UNITED STATES PATENT AND TRADEMARK OFFICE

10/732,804

Office Action Summary

DETAILED ACTION

FIG. 2
CONVENTIONAL ART

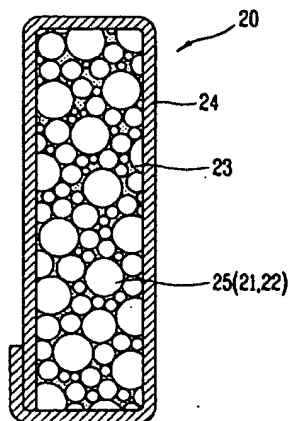
The AAPA makes known an electrode structure including a foam body 23 made of Ni in which mixture of electrode catalyst particles 21 made of metal halide (MH), and polytetrafluoroethylene 22 is infiltrated, and a mesh 24 made of Ni enclosing the foam body 23 (*See applicant's specification on page 3, lines 10-25/ FIGURE 2*).

The AAPA discloses in detail, a granule type electrode catalyst 21 and PTFE 22 mixed to a mixture 25 which is infiltrated in the foam body 23 to fill the void parts of the foam body 23; wherein the foam body 23 filled with the mixture 25 is enclosed by the mesh 24 which maintains the shape of the foam body 23 (*See applicant's specification on page 3, lines 10-25/ FIGURE 2*). *In this case, it is contended that either or both the foam body 23 and the mesh 24 act(s) as the claimed catalyst holding body; yet further, infiltration of the electrode catalyst granule-PTFE mixture in the foam body 23 encompasses certain degree of entanglement or wrapping or twisting. Note that the term "entangle" only means to wrap or twist together (Merriam-Webster's Collegiate Dictionary 10th Edition) but does not suggest any specific material and/or structure.*

Figure 2 below illustrates the conventional electrode structure disclosed by the applicant (See FIGURE 2).

The AAPA discloses a granule type electrode catalyst 21 (*See applicant's specification on page 3, lines 10-25/ FIGURE 2*).

The AAPA uses electrode catalyst particles 21 made of metal halide (MH) (*See applicant's specification on page 3, lines 10-25/ FIGURE 2*). It is noted that a metal halide is a hydrogen storage alloy.

The AAPA makes known an electrode structure including a foam body 23 made of Ni and a mesh 24 made of Ni enclosing the foam body 23 (*See applicant's specification on page 3, lines 10-25/ FIGURE 2*). In this case, it is contended that either or both the foam body 23 and the mesh 24 act(s) as the claimed catalyst holding body. Moreover, since the foam body 23 and the enclosing mesh are made of Ni, it is further contended that they represent a Ni-material contacting the electrode catalyst, thereby they serve as the claimed Ni layer.

The AAPA uses polytetrafluoroethylene 22 to make the electrode (*See applicant's specification on page 3, lines 10-25/ FIGURE 2*).
